MICHAEL KOHN ARCHITECT

ADDENDUM # 3

Project: **NEWBERRY MUSEUM** with bids due not later than **January 30, 3:00 PM.**

Date of this addendum: **January 25, 2018**

A1.1

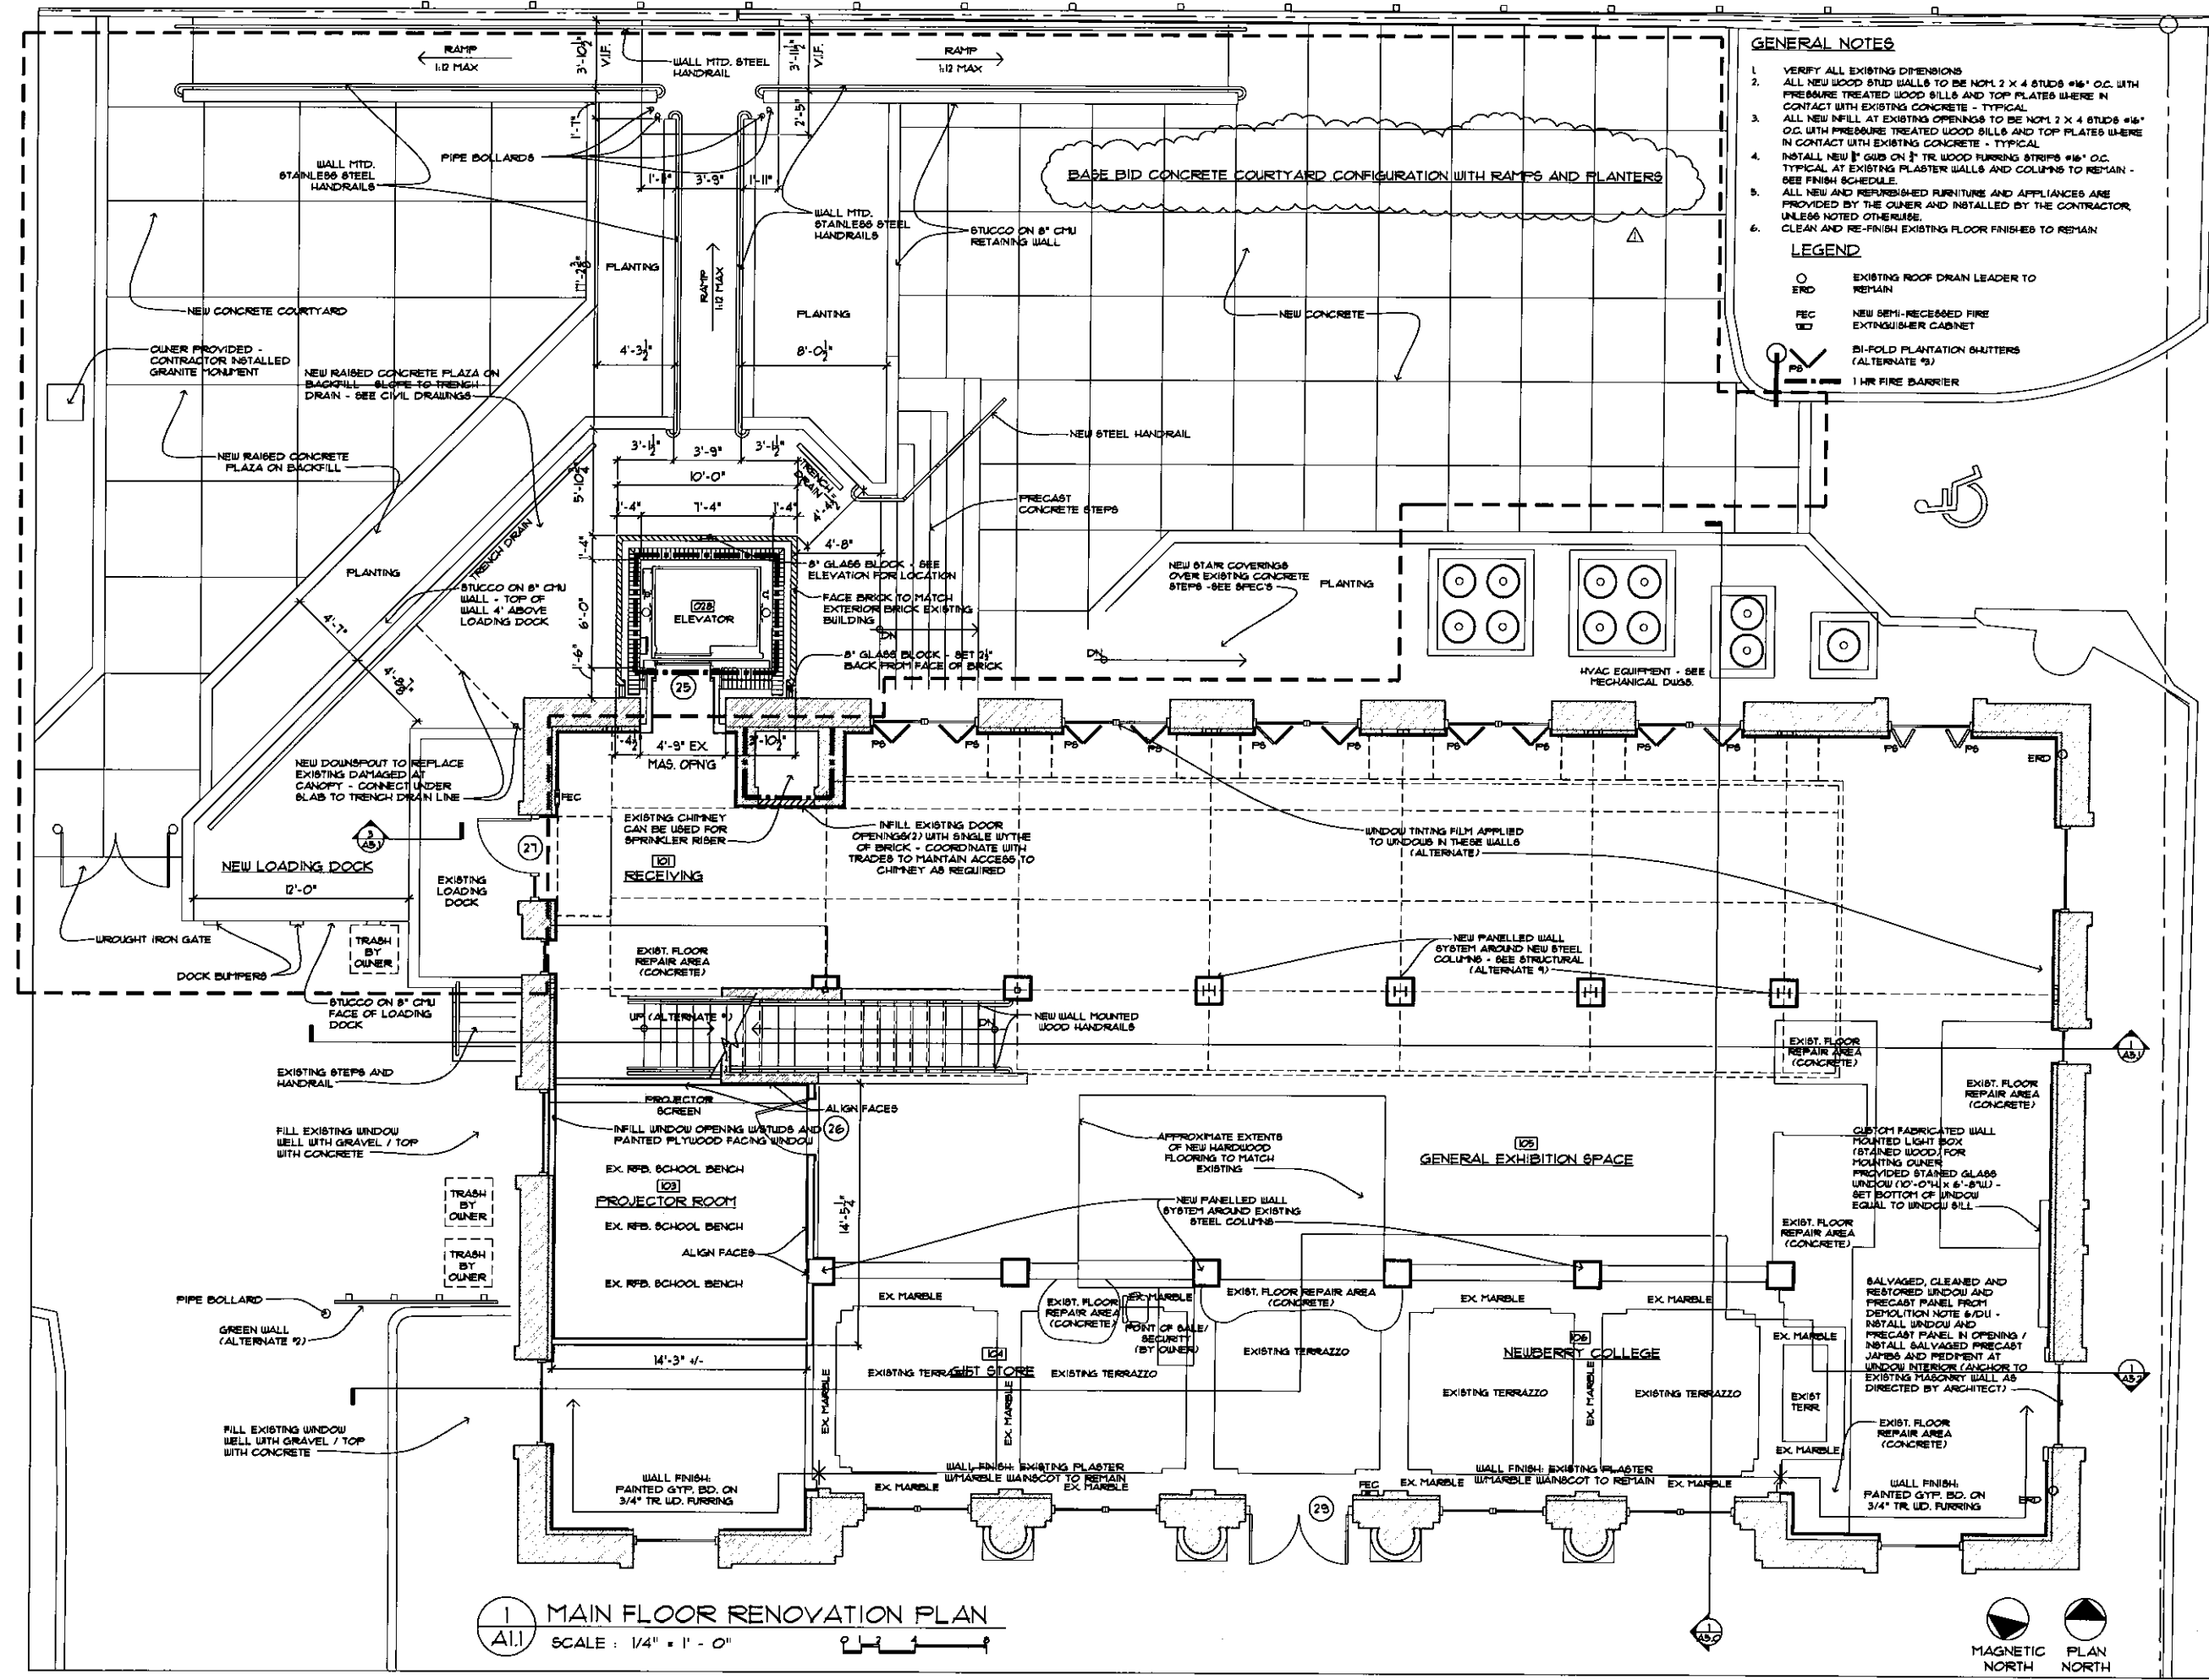
2. SHEETS A1.1 (revised); A1.15 (new); L2.1(new); L3.1(new); I-1.1 (new); E1.1 (revised); E1.1A (new); E2.1 (revised); and E2.1A (new) — see **Exhibits R-Z** — are all revised and/or inserted to reflect a Base Bid consisting of a fully-developed set of two rear courtyards, a vegetative screen on the rear property line, a T-shaped ramp, extended loading dock, stucco-covered CMU retaining walls, landscaping, irrigation, concrete paving, and lighting. This deductive alternate price would eliminate all the above except the vegetative rear yard fence, leaving a sod yard.

3. SHEETS A1.1 and A1.15: delete the word *ALTERNATE* which appears in a note on the main floor plan pointing to both the plan North and plan East walls. Tinting of the windows is to be installed whether base bid or any alternate bids are chosen.
